service bulletinM64-6
(Supersedes M50-7)

SUBJECT: Prevention of idling failures on four-cylinder engines.

ENGINES AFFECTED: All four-cylinder engines.

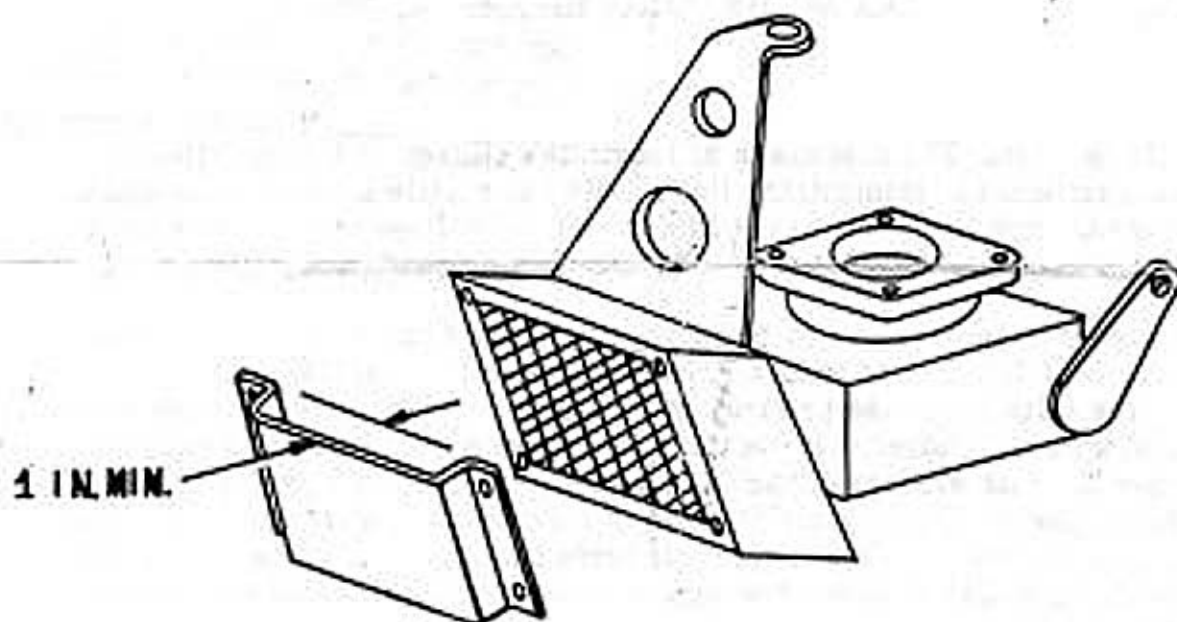
The foregoing is intended as helpful information to be remembered and applied whenever necessary. However, it is always a good safety measure to have a mechanical aid to help combat idling failures and we therefore refer you to the sketch illustrated below showing the suggested baffle arrangement which is very simple and can be very easily and economically made up and installed over the standard air filter. Our tests have indicated that this arrangement gives improved acceleration characteristics and minimizes the possibility of engine stoppage on sudden opening of the throttle.

1. Baffle metal must be stiff enough to prevent inward deflection toward the filter.
2. Note that a minimum distance of 1 inch must be maintained between baffle and filter as shown.
